STATE OF NORTH CAROLINA
DEPARTMENT OF TRANSPORTATION

SUBJECT: Environmental Permits for the Improvements to NC 150 in Catawba and Iredell Counties Division 12, **TIP: R-2307.**

DEPARTMENT OF THE ARMY PERMIT

Permit No. **SAW-2018-02343**

PERMIT DRAWING
SHEET 7 OF 22

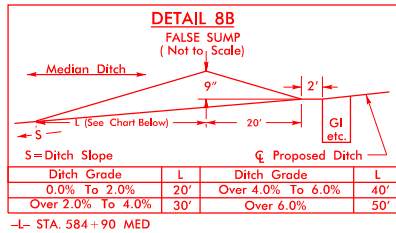
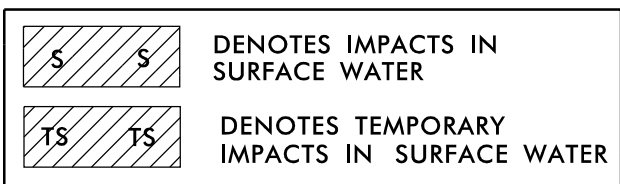
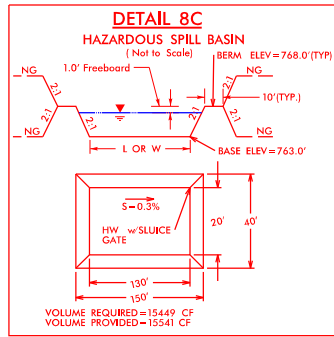
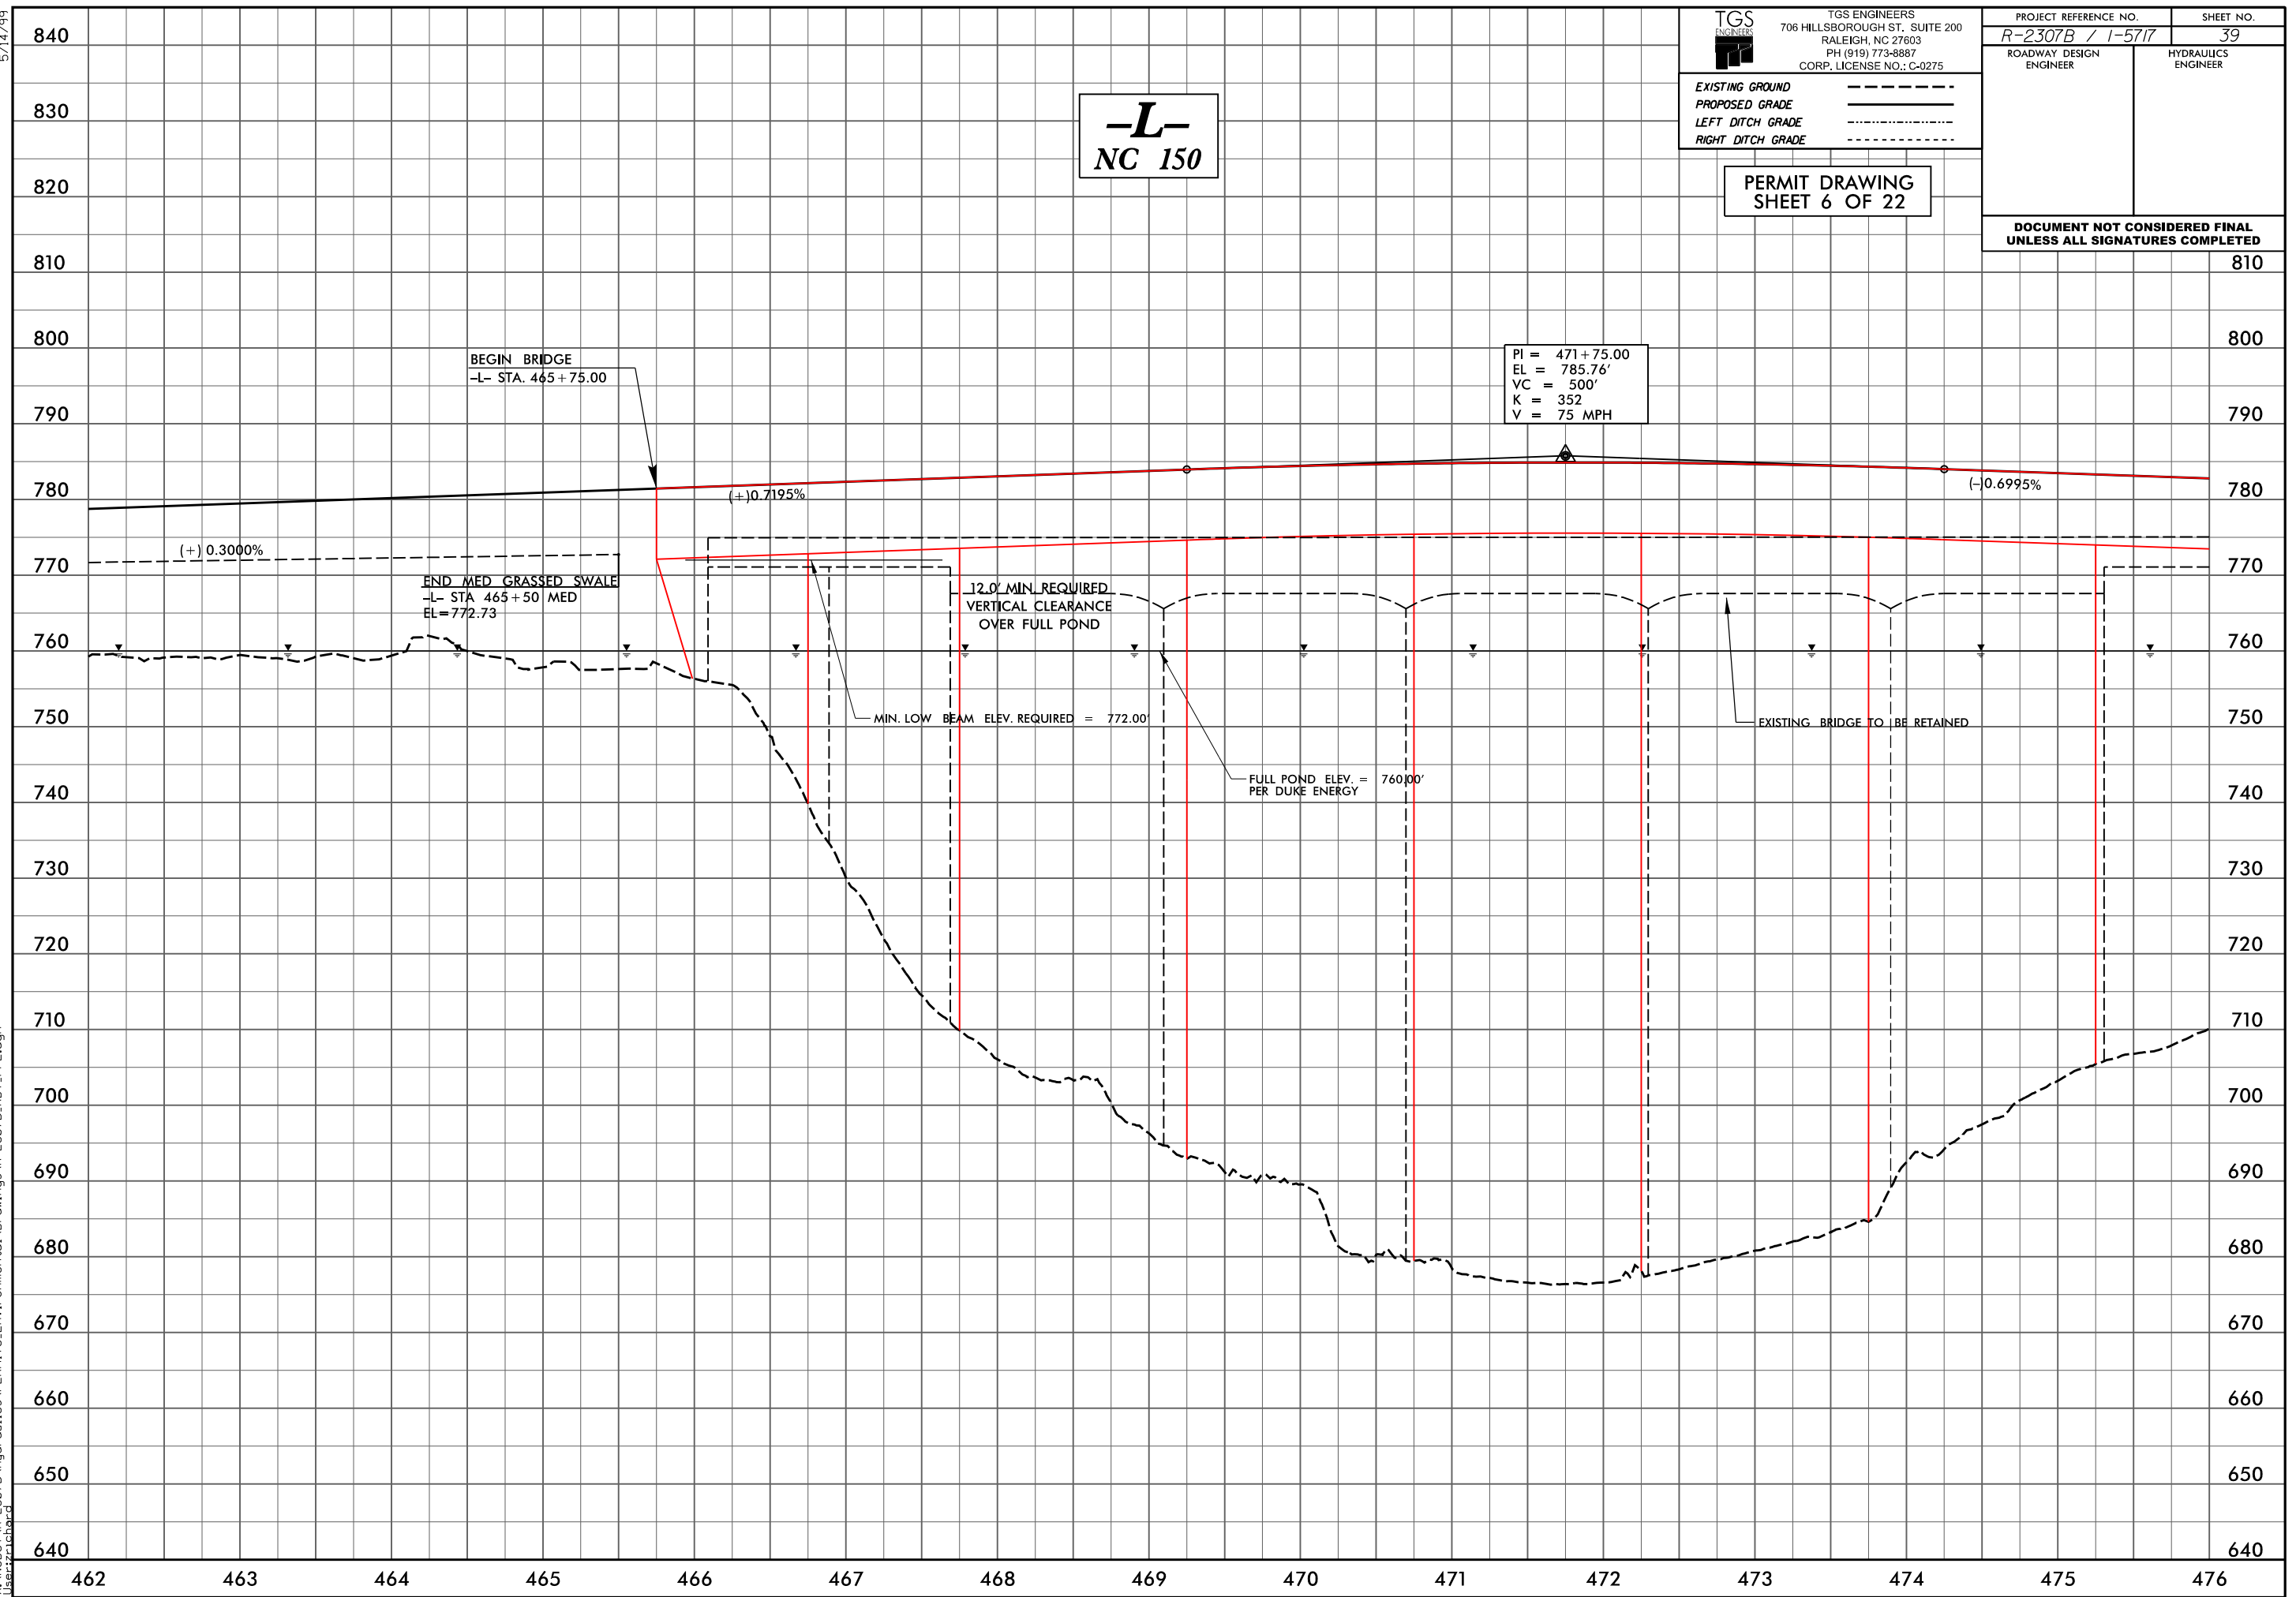
5. Site 4: Two temporary Surface Water Impacts were added down to elevation 750 ft on Permit Drawing Sheets 7-8. Temporary Surface Water Impacts increased from 0 to 0.162 acre.

NC DEPARTMENT OF TRANSPORTATION
DIVISION OF HIGHWAYS
1/29/2024
CATAWBA/IREDELL COUNTIES
R-2307B / I-5717
37944.1.FR5 / 50134.1.FS1
SHEET 22 OF 22

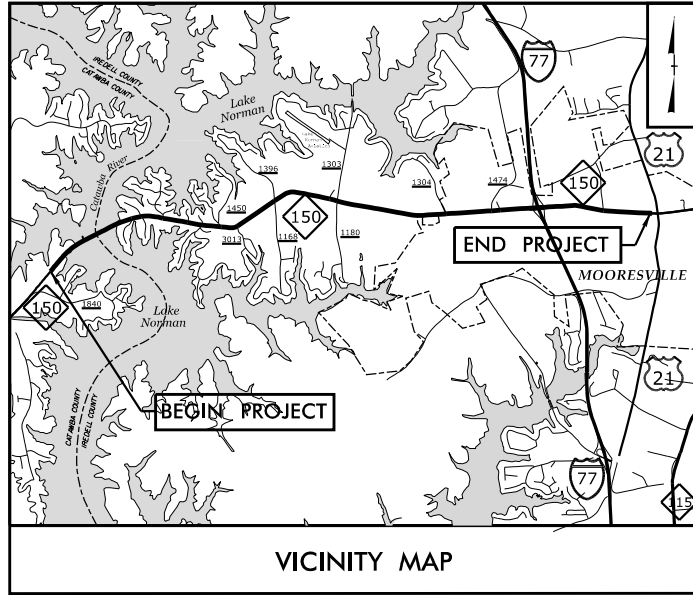
Site 12: Permanent impact decreased from 28 to 27 linear feet due to a corrected measurement (The change is only reflected on the Impact Summary Sheet, no change to the plan view).

7. Site 12: Permanent impact decreased from 28 to 27 linear feet due to a corrected measurement (The change is only reflected on the Impact Summary Sheet, no change to the plan view).

8. Impact Summary Sheet: Impacts on the previous version were shown to nearest 0.01 acre and now show the nearest 0.001 acre.
